**RE: HASCO 200<sup>th</sup> St Development (PDR-26-0001/SEPA-26-0003) – 1<sup>st</sup> Review Comments**

**Planning Division:**

**Plan Set Page S-C500:**

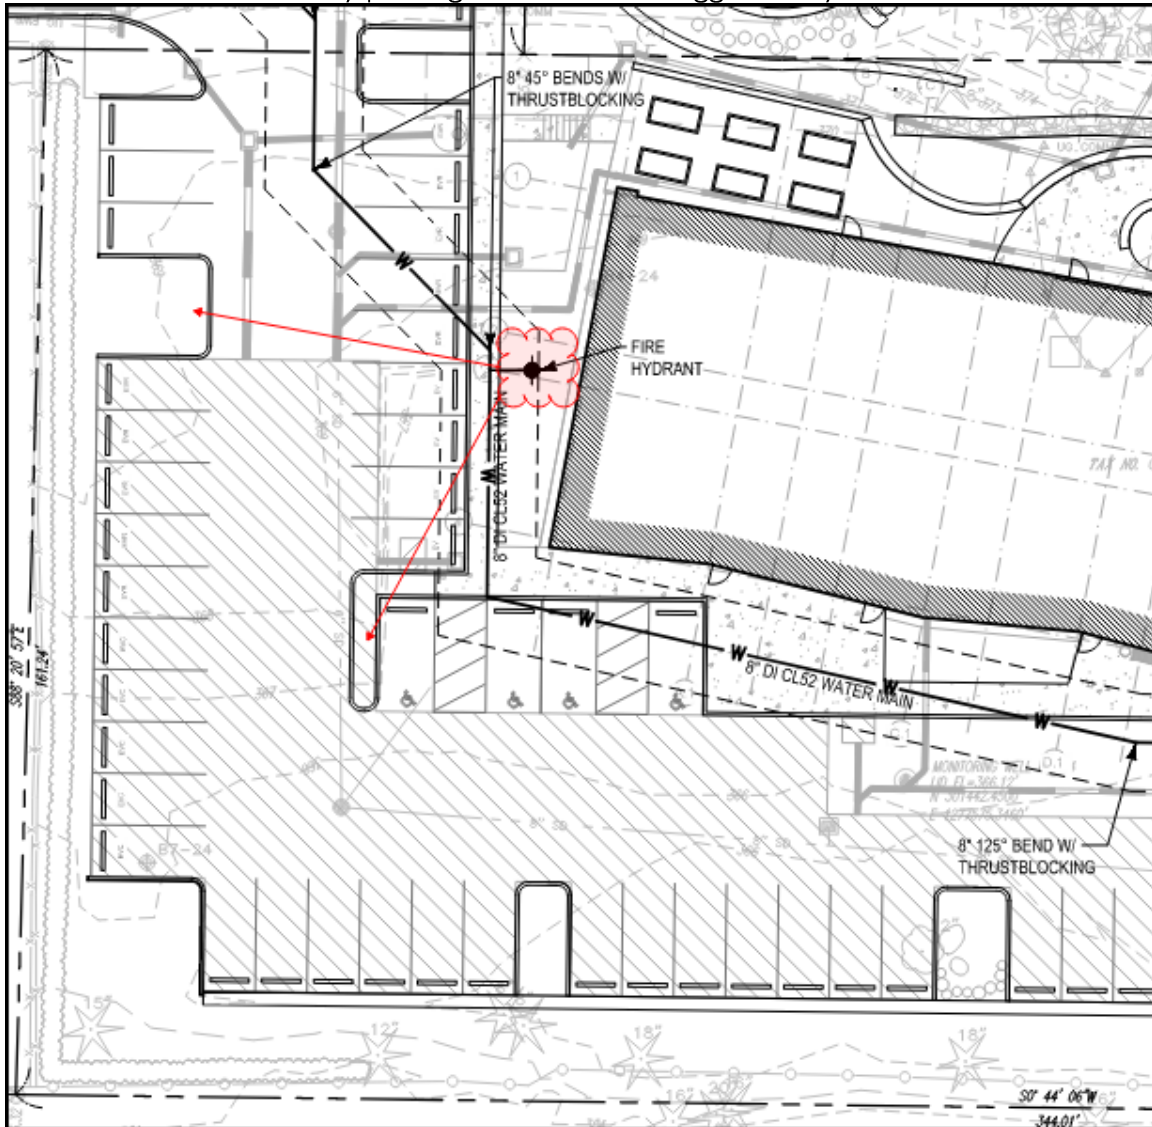
- COMMENT: With Development Engineering permit submittal, show that storm structures can support fire apparatus loads.

- COMMENT: With Development Engineering permit submittal, please locate this hydrant so it will not be blocked by parking. Two locations suggested by arrows.

- COMMENT: Both buildings, fire riser room must be separate from other spaces. Appears that domestic water, irrigation control, etc. is all in MEP room.
